NATURAL FEATURES REPORT

Riparian Analysis

January 18, 2023 (REV1)

V_2 Natural Landforms, Vegetation, Riparian Analysis.pdf Markup Summary

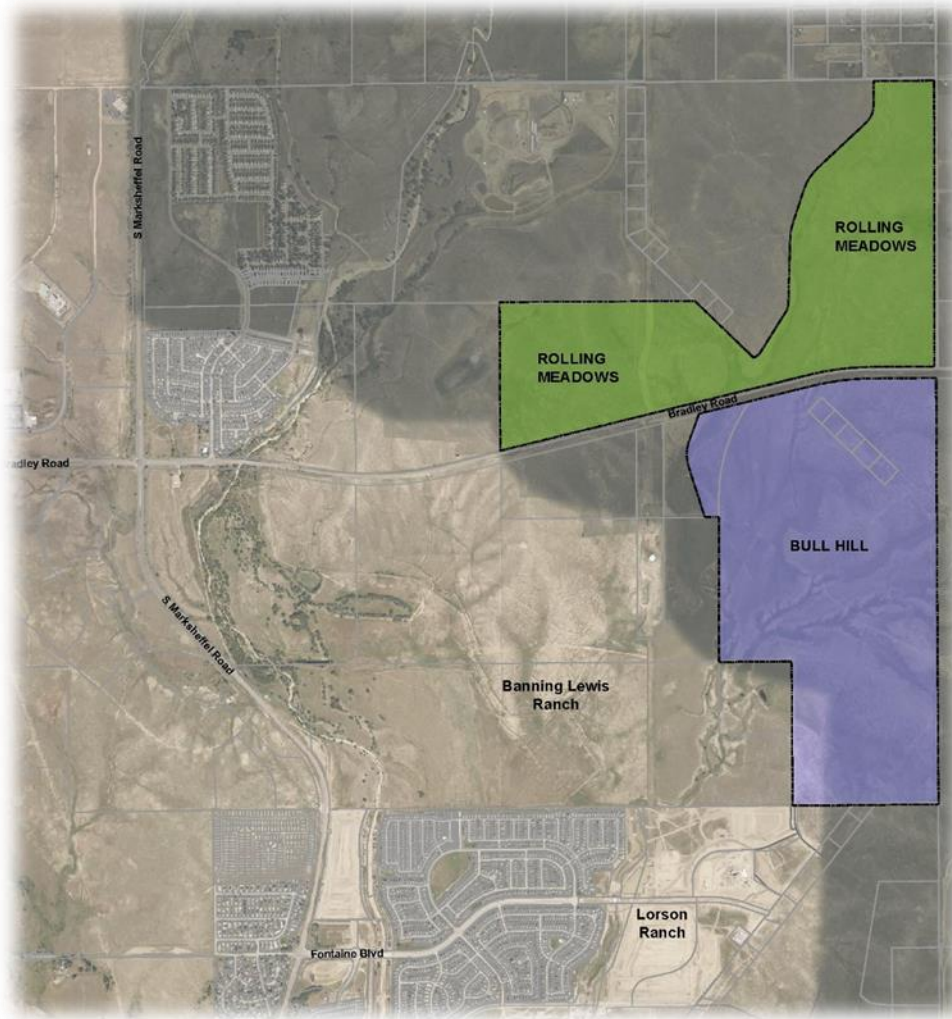
Please see the example Riparian study in Grandview Reserve SKP201 or Sterling Ranch East Phase 1 Prelim Plan (Filings 1-4) SP224 or Jaynes SKP 223. This should depict streams, intermittent streams, habitat- flora& fauna, it should include wetland areas both non jurisdictional and jurisdictional as well as other features. etc ..prepared by a qualified professional. **ROLLING MEADOWS/ BULL HILL** Repeat comment
